Well Name: TODD 13E FEDERAL	Well Location: T23S / R31E / SEC 13 / SWNW /	County or Parish/State: EDDY / NM
Well Number: 26	Type of Well: OIL WELL	Allottee or Tribe Name:
Lease Number: NMNM0404441	Unit or CA Name:	Unit or CA Number:
US Well Number: 3001532632	Well Status: Temporarily Abandoned	Operator: HARVARD PETROLEUM COMPANY LLC

Notice of Intent

PLUG AND ABANDONMENT CONDITIONS OF APPROVAL

OPERATOR'S NAME:	Harvard Petroleum Company LLC
LEASE NO.:	NMNM0404441
WELL NAME & NO.:	Todd 31E Federal 26
US Well Number:	3001532632
LOCATION:	Section 13, T.23 S., R.31 E., NMPM
COUNTY:	Eddy County, New Mexico
Sundry ID:	2723452
Karst:	<input type="checkbox"/> Low <input type="checkbox"/> Medium <input type="checkbox"/> High <input type="checkbox"/> Critical
Potash:	<input type="checkbox"/> Secretary <input checked="" type="checkbox"/> R111P
Special Area:	<input checked="" type="checkbox"/> Prairie Chicken <input type="checkbox"/> Capitan Reef

BLM Approved Plugs

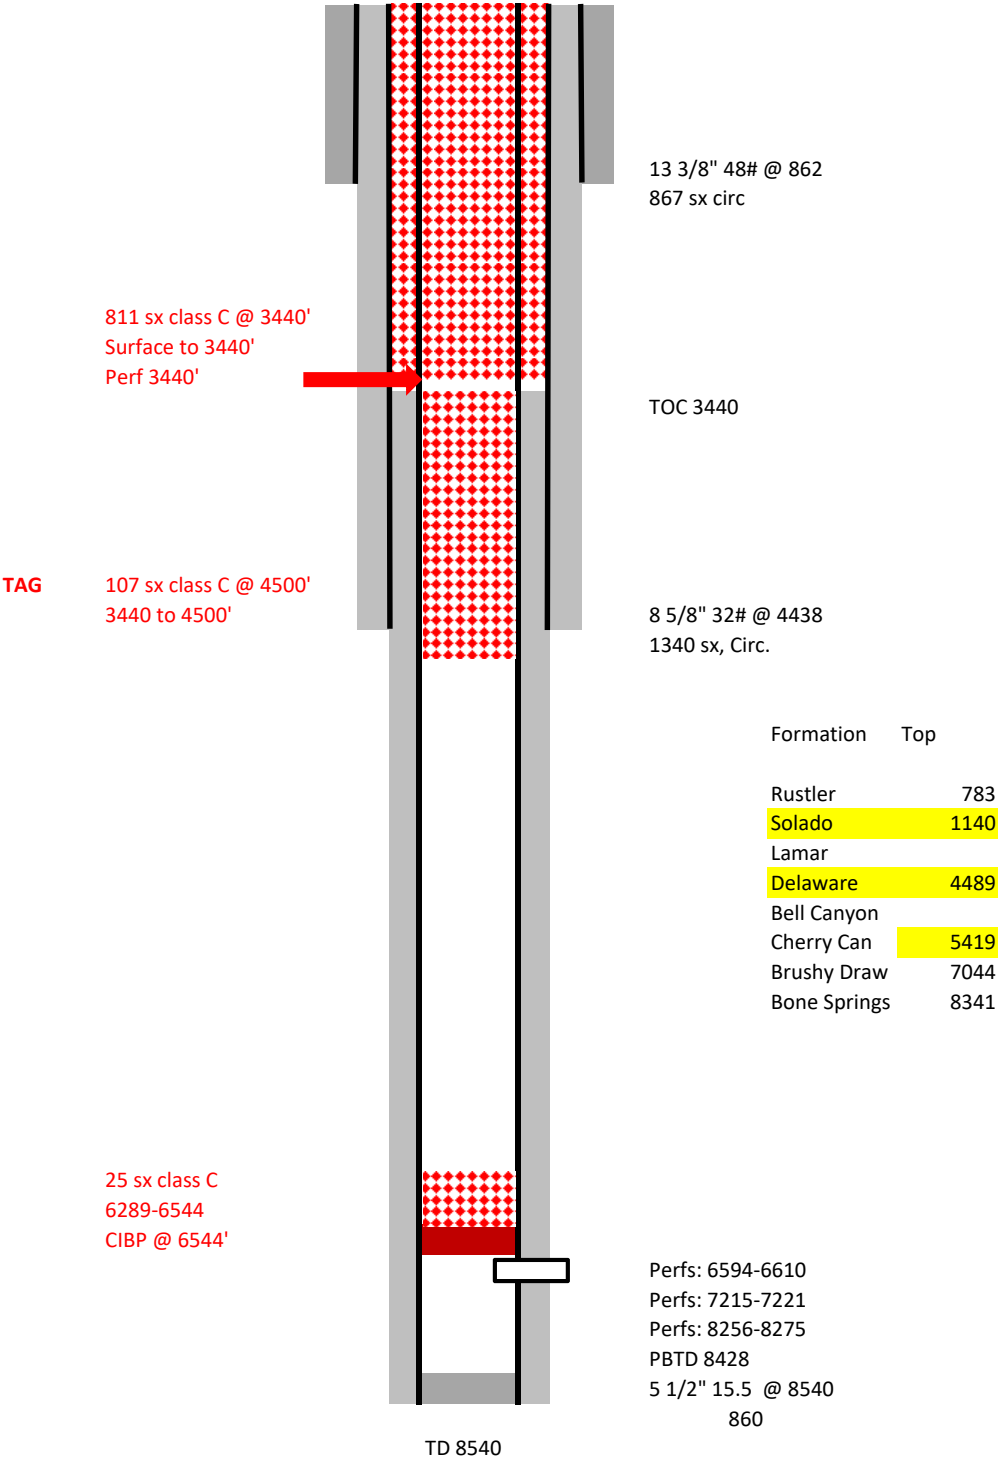
- No more than 3000 feet between cement plugs in cased hole.
- Wait on Cement and Tag Top of Cement Requirement:
 1. Shoe, Top of Salt, Base of Salt, DV tool, Perforate and Squeeze, Open Perforation.
 2. Formation plug is optional if a solid base is established and confirmed.

Sundry ID		2723452					
Plug Type	Top	Bottom	Length	Tag	Sacks	Cement Class	Notes
Surface Plug	0.00	100.00	100.00	Tag/Verify			
Fresh Water @ 811	752.89	861.00	108.11	If solid			
Shoe Plug	803.38	912.00	108.62	Tag/Verify			
Top of Salt @ 1140	1078.60	1190.00	111.40	Tag/Verify			
Base of Salt @ 4212	4119.88	4262.00	142.12	Tag/Verify	811.00	C	Perforate and squeeze at 3440' to surface. (In 349 sxs/Out 462 sxs) Verify at surface.
Shoe Plug	4343.62	4488.00	144.38	Tag/Verify			
Delaware @ 4450	4355.50	4500.00	144.50	If solid base no need to Tag (CIBP present and/or Mechanical Integrity Test), If Perf & Sqz then Tag, Leak Test all CIBP if no Open Perforations	107.00	C	Spot cement from 4500' to 3440'. WOC and Tag.
CIBP Plug	6509.00	6544.00	35.00	If solid base no need to Tag (CIBP present and/or Mechanical Integrity Test), If Perf & Sqz then Tag, Leak Test all CIBP if no Open Perforations	25.00	C	Set CIBP at 6544'. Spot 25 sxs on top. Leak test CIBP.

Perforations Plug (If No CIBP)	6544.00	8325.00	1781.00	Tag/Verify			
Bonesprings @ 8290	8157.10	8340.00	182.90	If solid			
Shoe Plug	8404.60	8590.00	185.40	Tag/Verify

No more than 2000' is to be allowed between plugs in open hole, and no more than 3000' between plugs in cased hole.
